DRAFT A
MARCH 1993

PRELIMINARY DRAFT LFI/FFS FOR 1100-EM-2, 1100-EM-3 & 1100-IU-1.

ADDENDUM TO DOE/RL-92-67

FIGURE 1.1

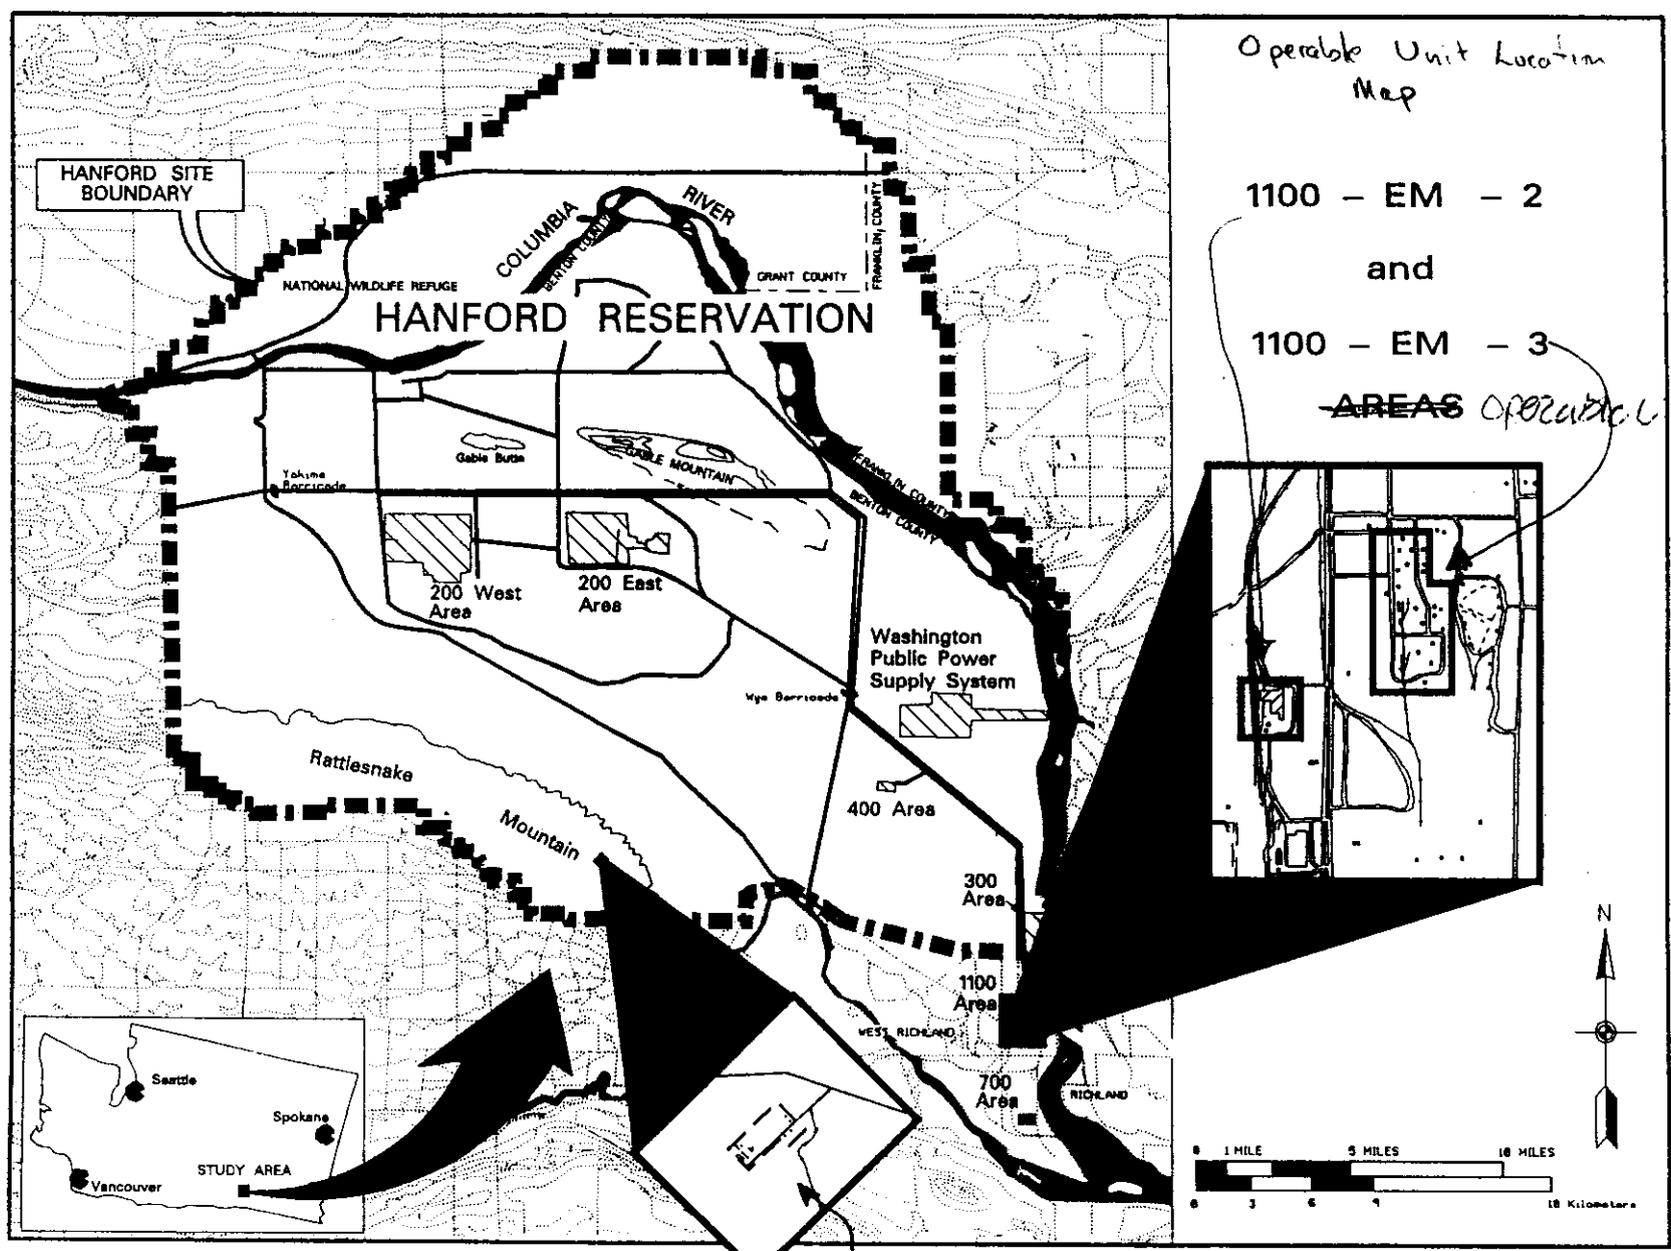
~~AREAS~~ OPERABLE UNITS

Figure 102

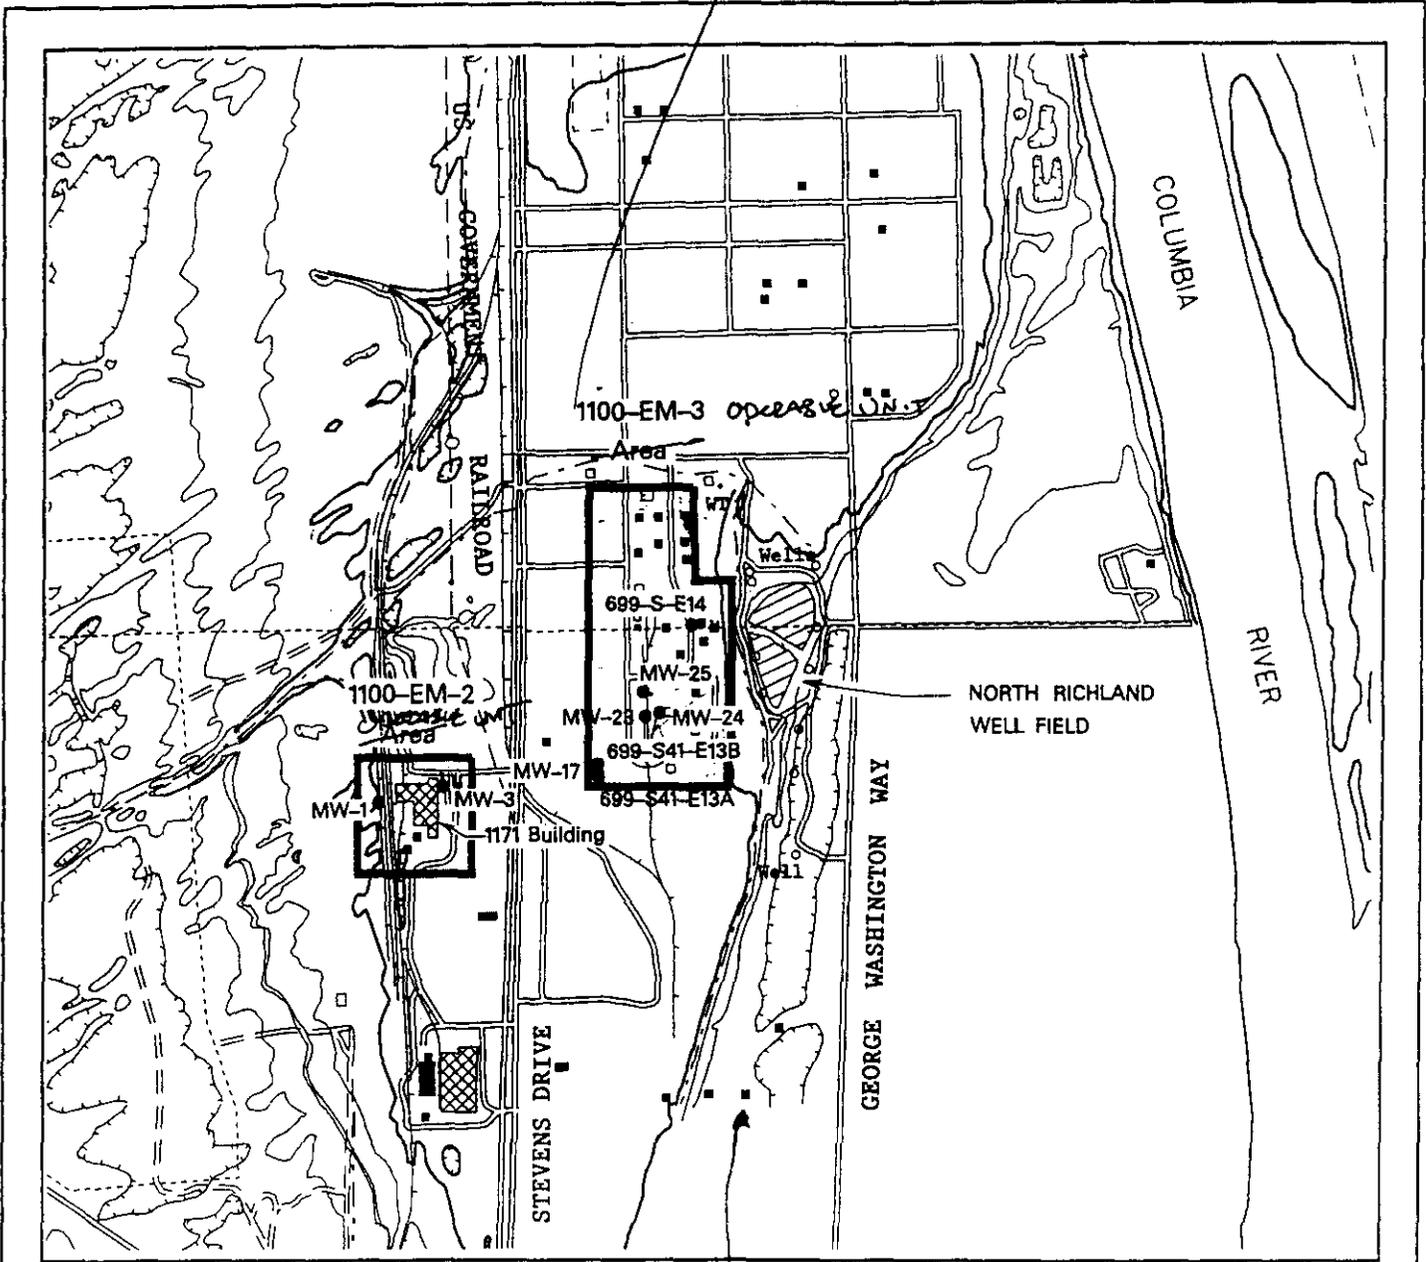
needs to be bolder type !!
(+ why not a little bigger?)
